Appendix S

Response to Comments

SUBJECT: HARMON RANCH SPECIFIC PLAN (PROJECT), DRAFT ENVIRONMENTAL IMPACT REPORT (DEIR), SCH #2023020009

I10-51

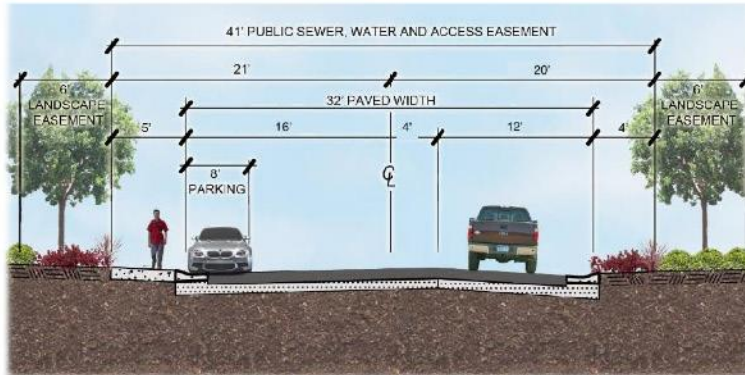
These streets do not meet Poway General Plan specifications for urban streets which are required for all residential zones RS-4 and above.

The streets are not capable of handling the parking needs of similar neighborhoods.

The drawing of the Specific Plan is labeled "Not To Scale" which is true, but also very misleading. The 5' ft sidewalk appears larger than the 8' ft parking area. And the 8 ft parking area should take up about half of the 16 ft paved width.

- I10-52** The commenter provides Exhibit 4.2 from the Specific Plan, Appendix Q of the Draft EIR, and makes comments related to the exhibit and the design of the streets. The comment does not relate to any physical effect on the environment and does not raise an issue related to any specific section or analysis of the Draft EIR. Nonetheless, Exhibit 4.2 in the Specific Plan has been revised.
